1199 Superleggera Model Year 2014 1299 Superleggera Model Year 2017 1299 Panigale R Final Edition Model Year 2018 Panigale R Model Year 2015-2017 Safety Recall Bulletin SRV-RCL-19-002

Based on continued quality tests and service reports, it was identified that the engine vapor breather system could operate incorrectly, with possible consequent leakage of engine oil from the Airbox breather tube.

All motorcycles involved in this Safety Recall Campaign will be upgraded by installing the kit part no.69929001A characterized by a new completely redesigned cyclone separator to prevent the operational issues.

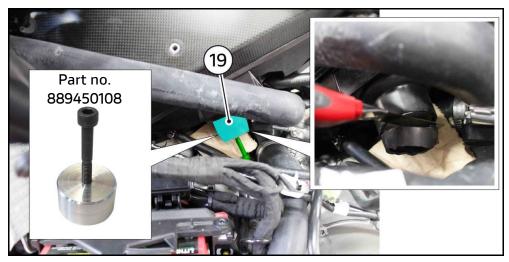
23. Take the tool part no.889450108, insert the buffer in the cyclone **hose (19)** driving it fully home and remove the excessive section of hose using a cutter.

<u>During the trimming operation, protect the surrounding components around the cyclone hose to avoid damaging the coolant hoses</u>

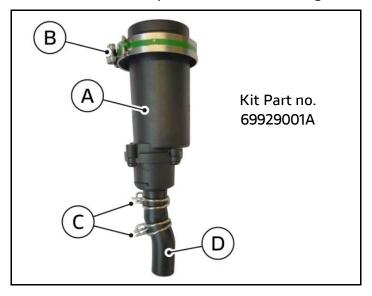
Check that the remaining length of the cyclone **hose (19)** is equal to approx. 30 mm and remove both the protection used and the tool part no.889450108.

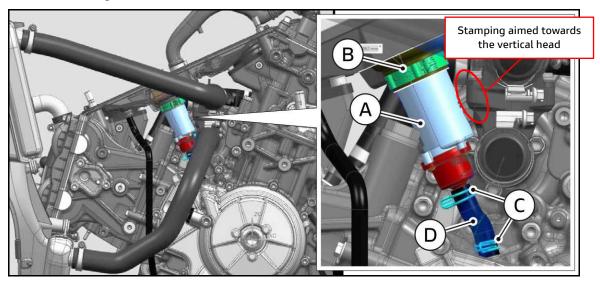
24. Take the kit part no.69929001A and assemble the **cyclone separator (A)**, the **click clamp (B)**, the **rubber hose (D)** and the **2 clamps (C)** as shown in the figure

- 25. Install the cyclone separator (A) inside the cyclone hose aiming the stamping towards the vertical head, as shown in the figure. Fasten the cyclone separator using the click clamp (B)
- **26.** Insert the terminal part of the **hose (D)** in the crankcase and aim the **2 clamps (C)** as shown in the figure
